No. Bulletin #01-

085

Model 520 HVAC Service Ports Spaced Incorrectly

Bulletin #01-085

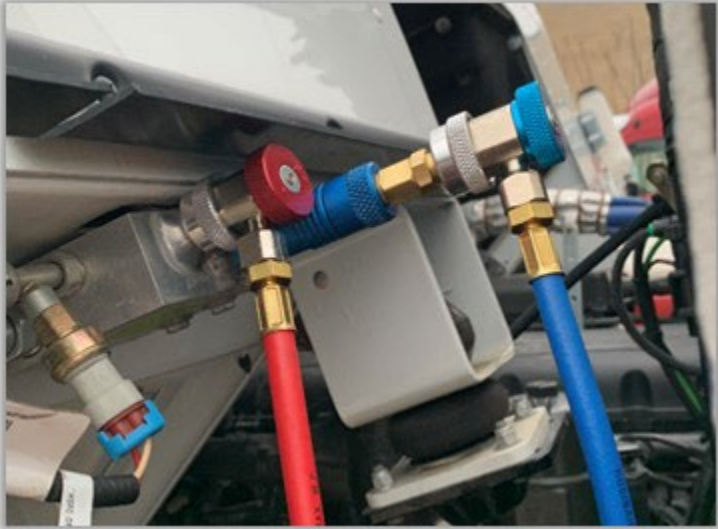
Title (metadata)	Bulletin #01-085: Model 520 HVAC Service Ports Spaced Incorrectly
Description	Model 520 HVAC Service Ports Spaced Incorrectly
Bulletin No.	Bulletin #01-085
Bulletin Category	Field Service
Supplier (Recall Only)	
Image	
Service Subject	Model 520 HVAC Service Ports Spaced Incorrectly
Section	HVAC - 01
What's New Abstract	Info Only – Certain 520 model chassis built between 2014 and 2021, and equipped with the Red Dot HVAC system, may have service port spacing which will not allow the connection of a pressure gauge to both the high and low side service ports simultaneously. A specific tool is available from the supplier that will allow a technician to bypass this design issue.
Revision	
Condition / Chief Complaint	HVAC service ports are spaced too closely together and prevent a technician from connecting a pressure gauge to both high and low side service ports at the same time.
Chassis Affected	520 model chassis with Red Dot HVAC system.

Service Action	<p>Information Only A tool is available for dealerships to purchase and use to bypass the current design.</p>									
Parts	<p>Parts are available from supplier "AirSept".</p>

<p>*Purchase either the High or Low side extender part listed above as either one will work to bypass the current design.</p> 	Quantity	Part Number	Description	1*	90003	High Side Extender	1*	90033	Low Side Extender
Quantity	Part Number	Description								
1*	90003	High Side Extender								
1*	90033	Low Side Extender								
Background										
Procedure
